## Final MYO Monitoring Report

Owen Farms Mitigation Site  
Transylvania County, NC

NCDMS Project No. 100064  
NCDMS Contract No. 7532  
NCDMS RFP No. 16-007334  
(Issued 9/8/2017)

Re: MY0 As-Built Baseline Monitoring Report Comments  
Owen Farms Stream and Wetland Mitigation Site  
French Broad River Basin; CU# 06010105 – Transylvania County  
DMS Project ID No. 100064  
Contract No. 7532

**PROJECT ASSET MAP**  
**OWEN FARMS MITIGATION SITE**  
 FIGURE 2.0  
 OWEN FARMS AS-BUILT REPORT

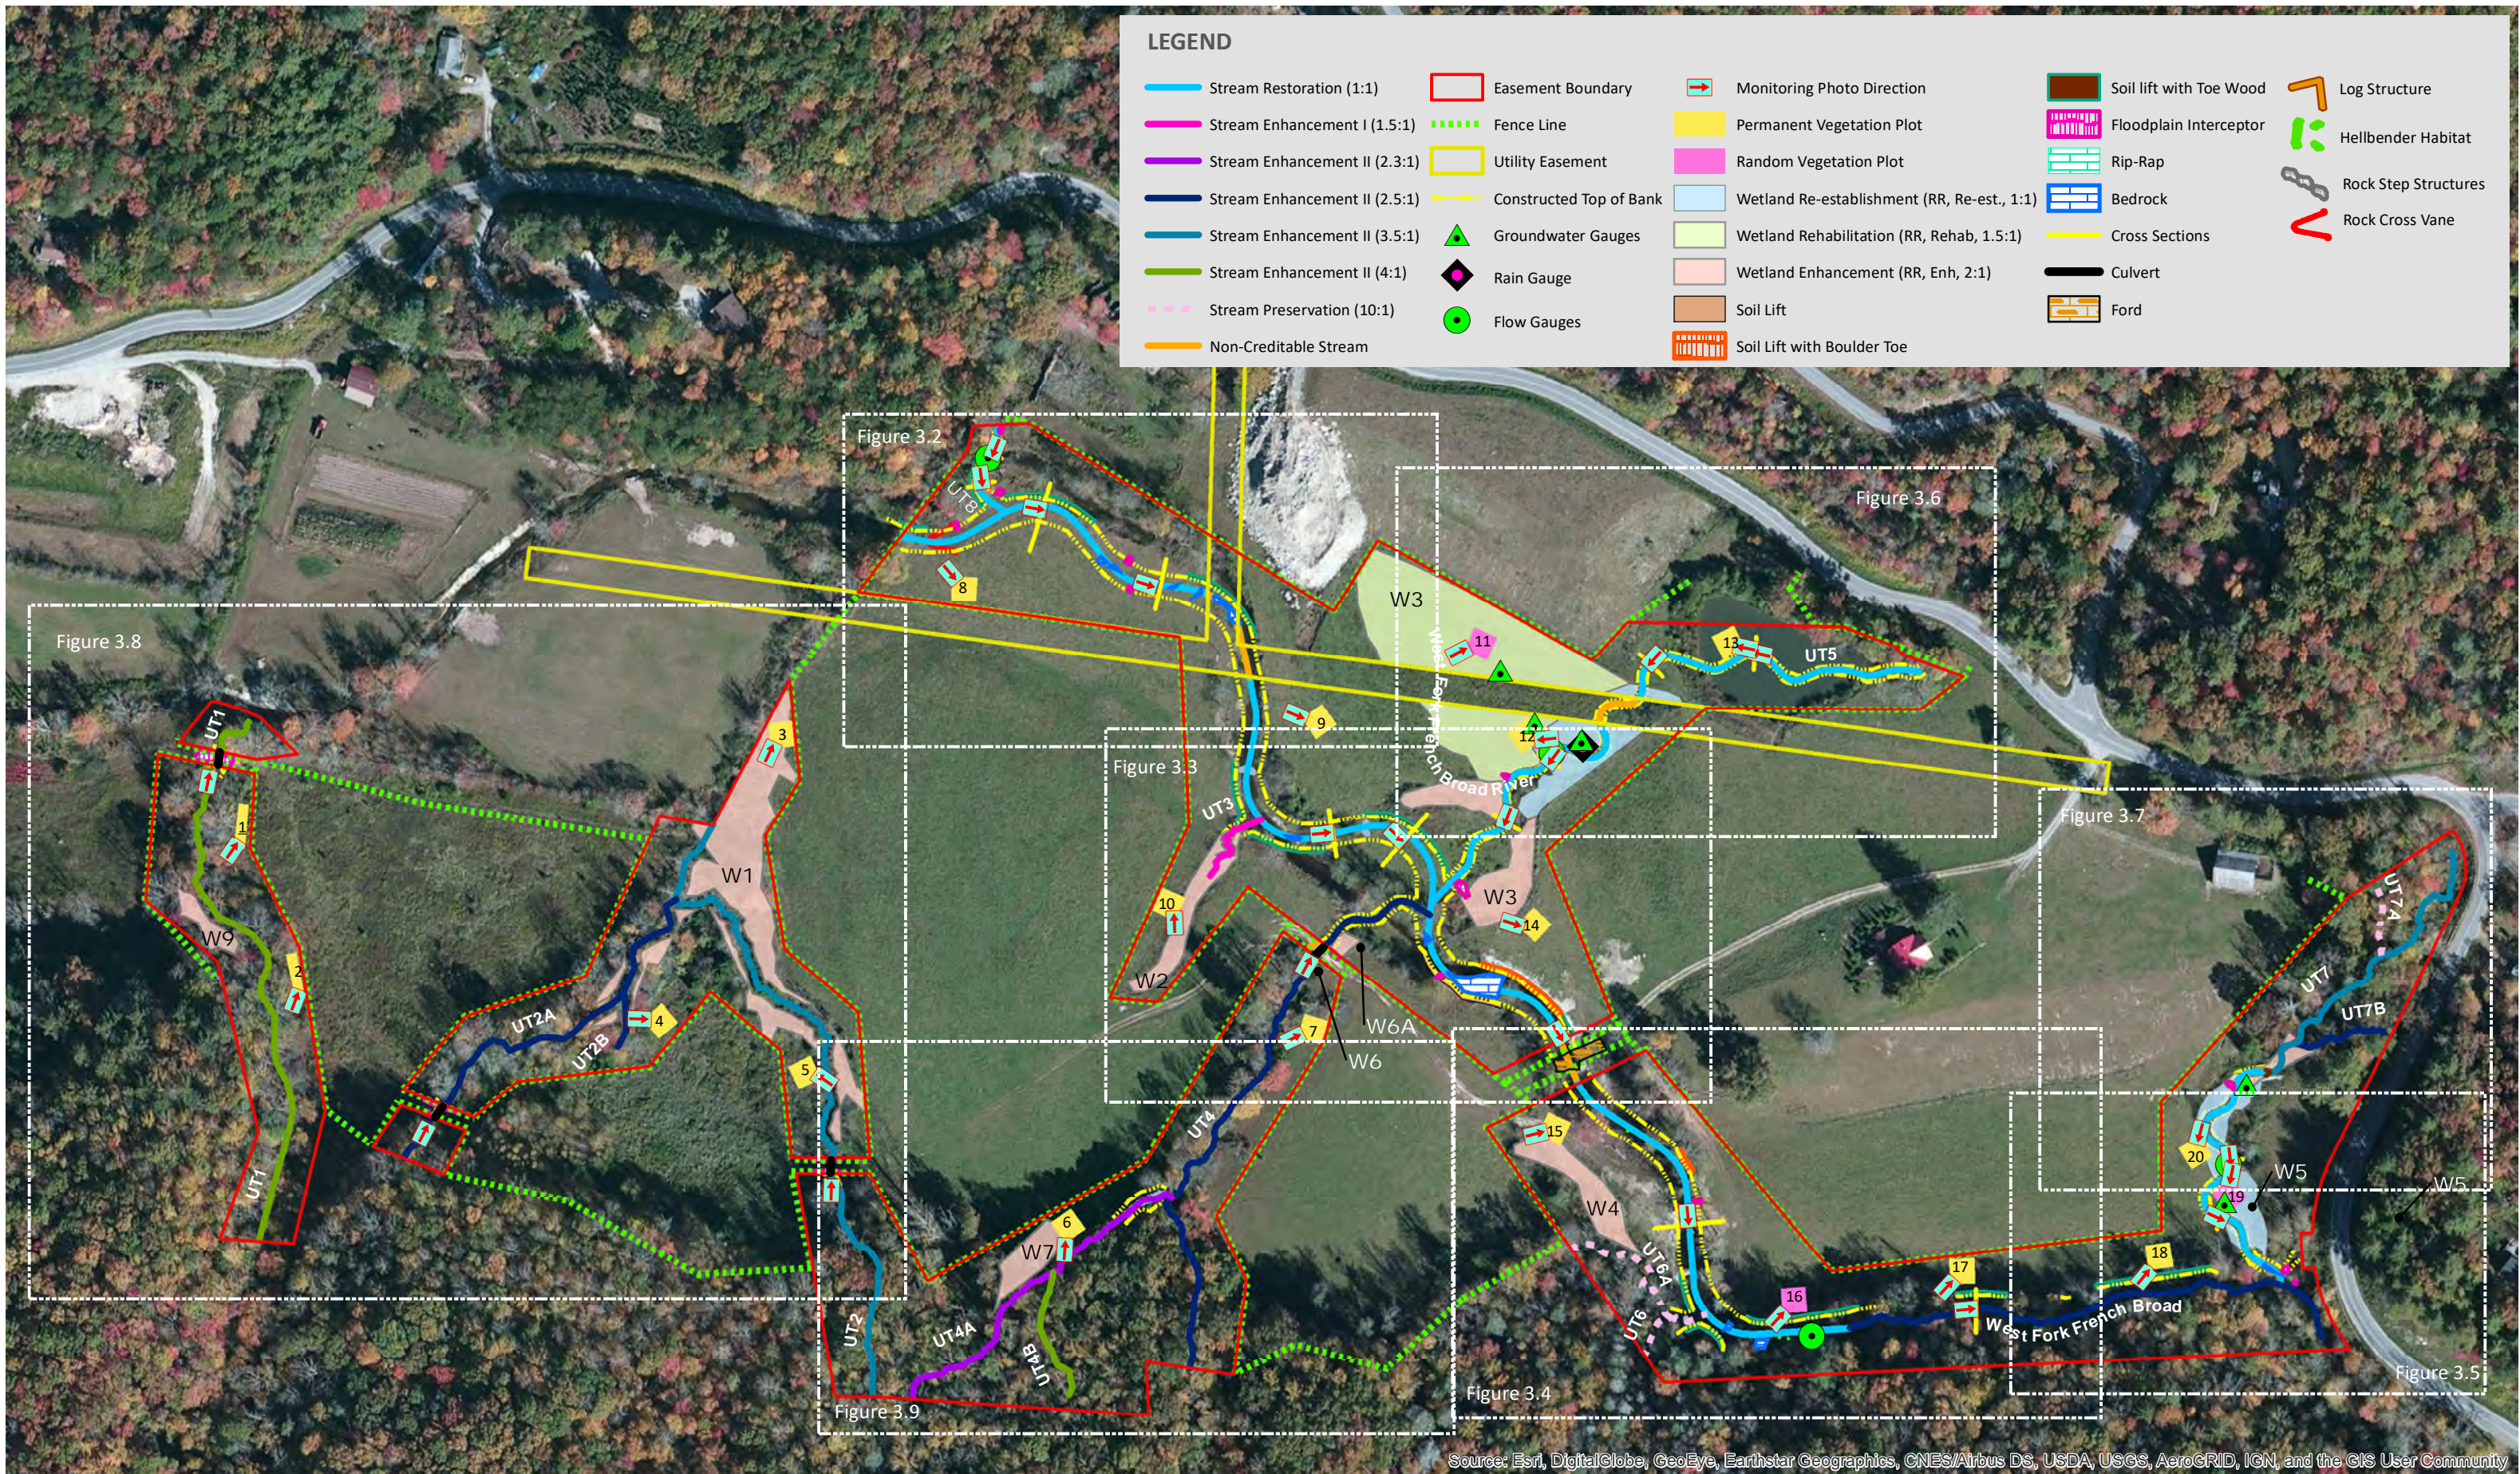
12. Appendix A – All Figures: The IRT has requested that the mapping legend asset colors and symbols remain consistent throughout the life of the project. The mapping legend asset colors and symbols in the draft MY0 report differ from what is presented in the IRT approved mitigation plan. If HDR believes that the mapping legend asset colors and symbols presented in the draft MY0 report better represent the project, please briefly discuss and note the change in the report

15. Appendix A – Figure 2.0 Project Asset Map & As-Built Monitoring Plan View: Please label all project streams and wetland assets on the Project Asset Map to identify the stream segments and wetland areas presented in Table 4 (Project Mitigation Quantities and Credits). Project reaches and wetlands areas should also be labeled on figure 3.1.

*RE: Comply. The colors of the assets in Figures 2 & 3 have been updated to be consistent with what was presented in the Asset Map of the Mitigation Plan.*

**AS-BUILT MONITORING PLAN VIEW**  
**OWEN FARMS MITIGATION SITE**  
 FIGURE 3.4  
 OWEN FARMS AS-BUILT REPORT

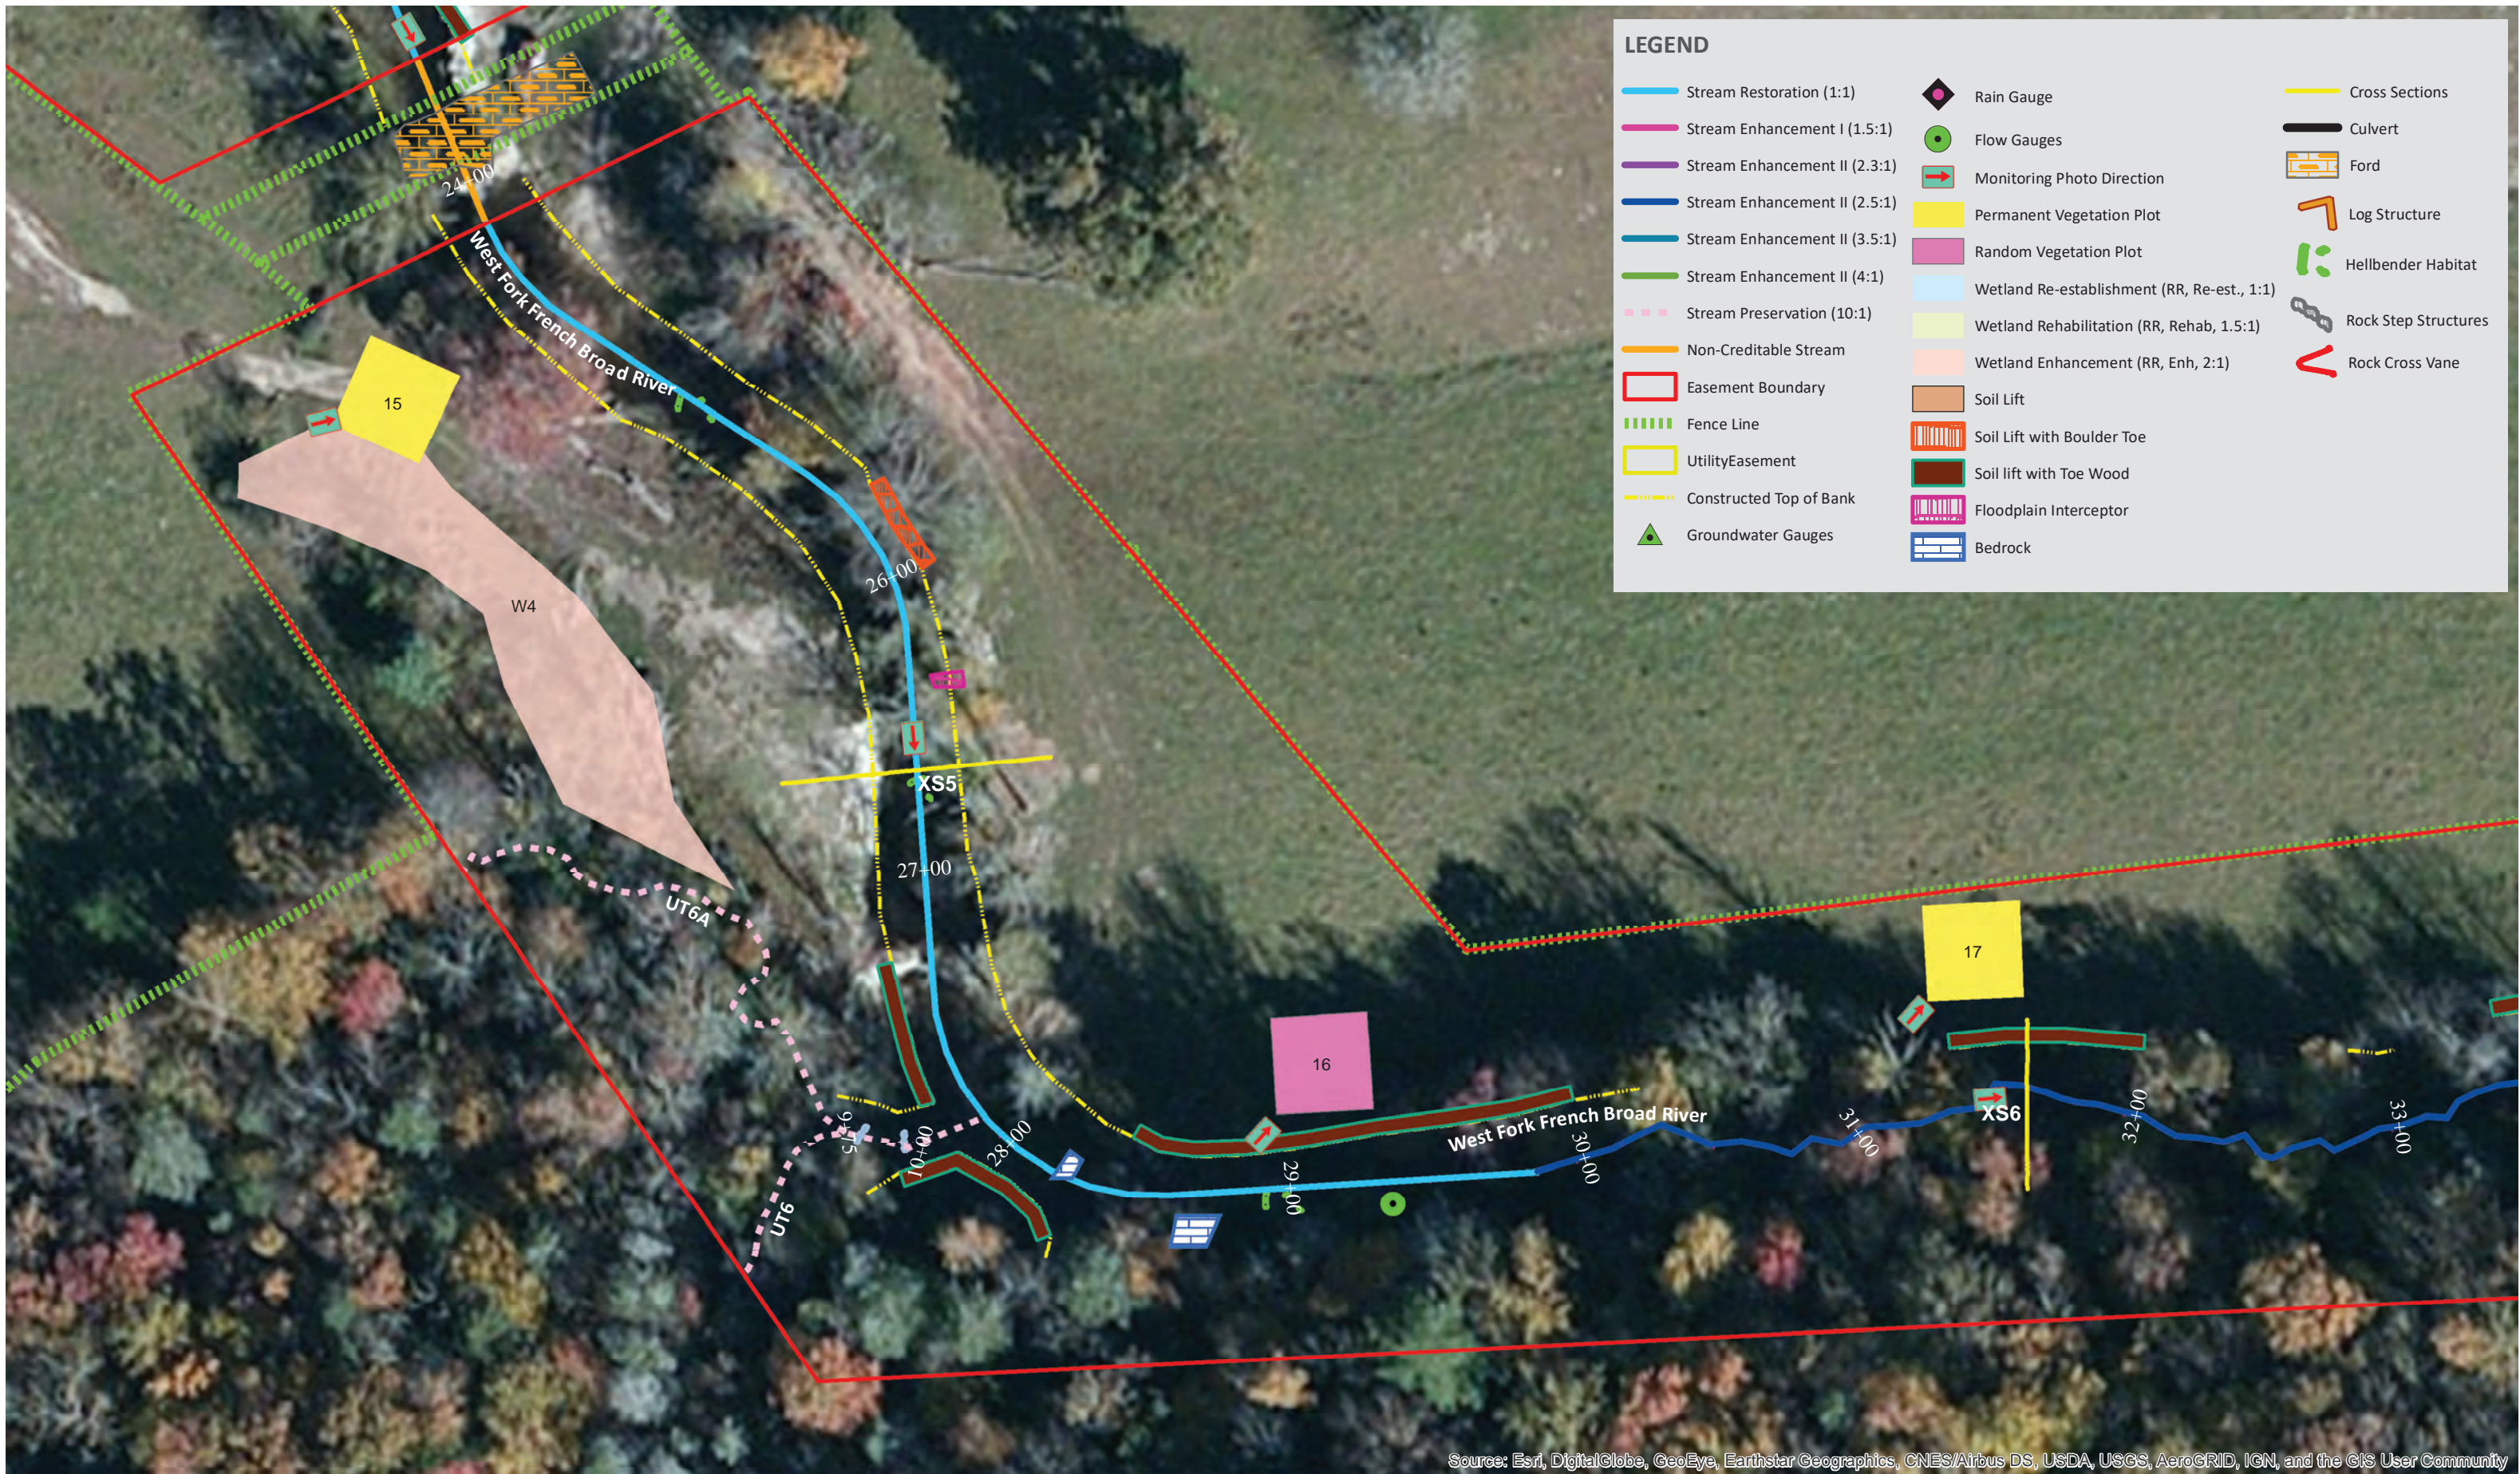
Please also review the as-built monitoring plan view maps to confirm that all project streams and wetland assets areas are labeled. As an example, UT7 is not labeled on figure 3.5. Asset labeling should also be utilized in all future monitoring report figures.

### Figure 4.10 UT 4 - Longitudinal Profile

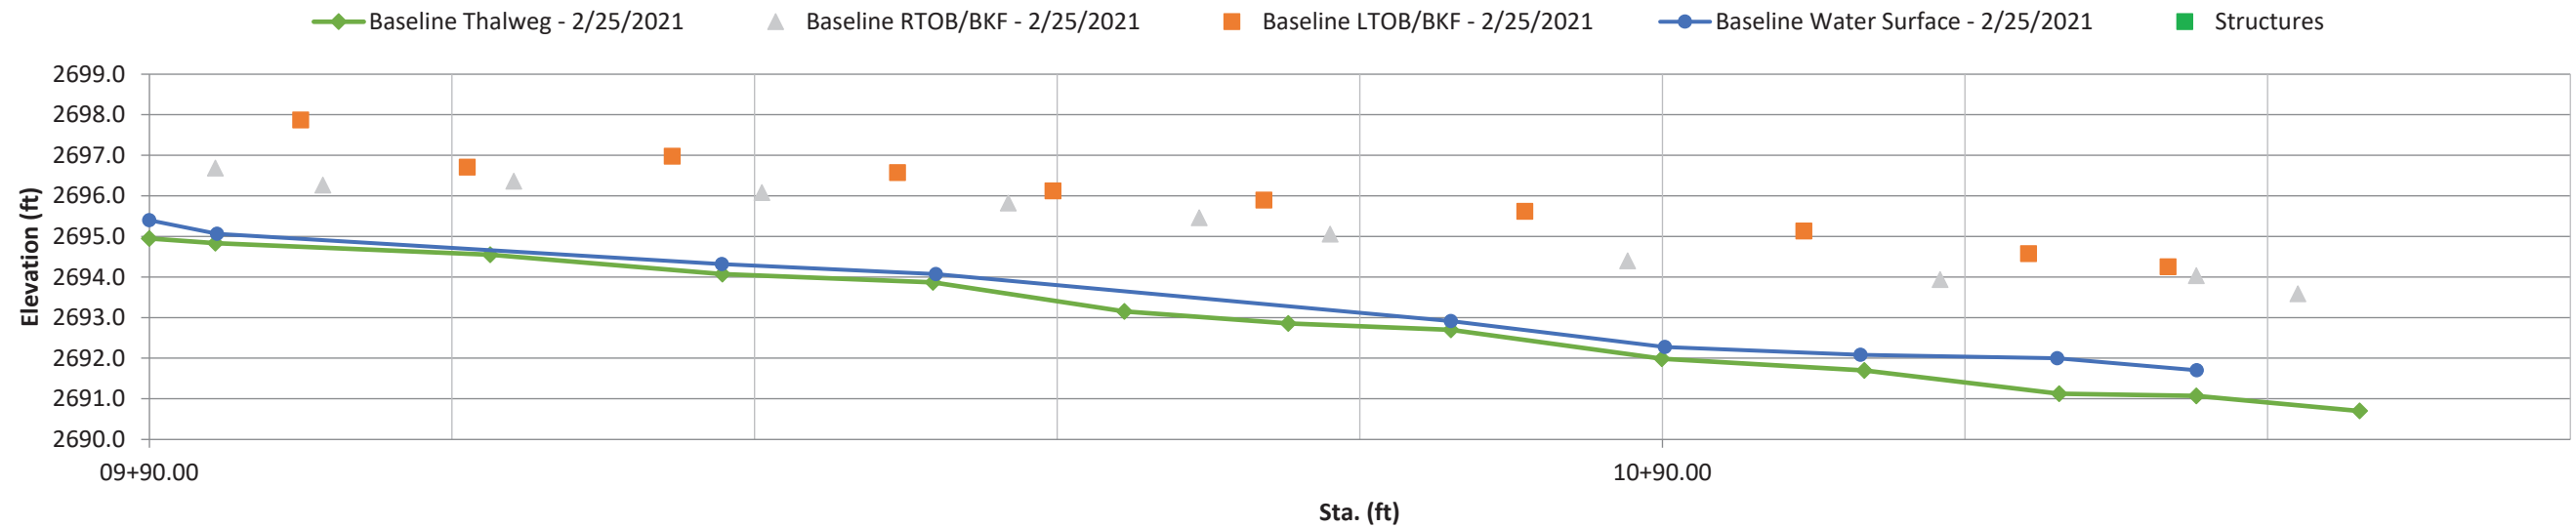
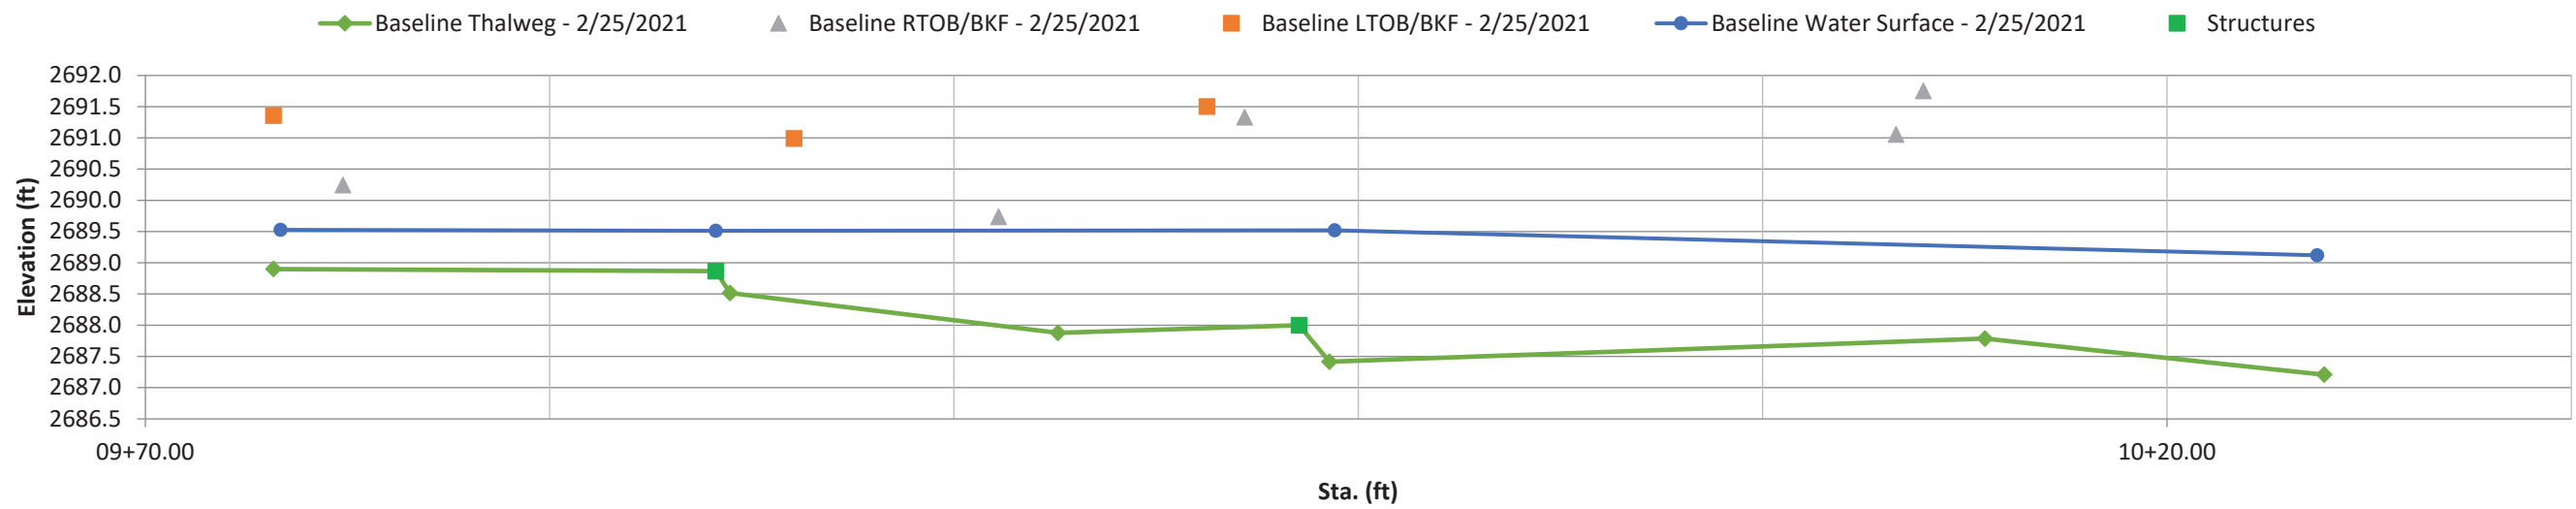
16. Appendix A – As-Built Monitoring Plan View Figures: Please review and confirm that the stationing shown on the as-built monitoring plan view maps is accurate and matches the longitudinal profiles provided. There appears to be minor discrepancies for UT3; UT4; and UT6. Please review all stationing shown on the maps & record drawings to confirm they are consistent with the longitudinal profiles and cross sections provided in the report. Please update as necessary.

*RE: Comply. The longitudinal profile stationing has been updated to match the plan view figures for UT3, UT4, and UT6.*
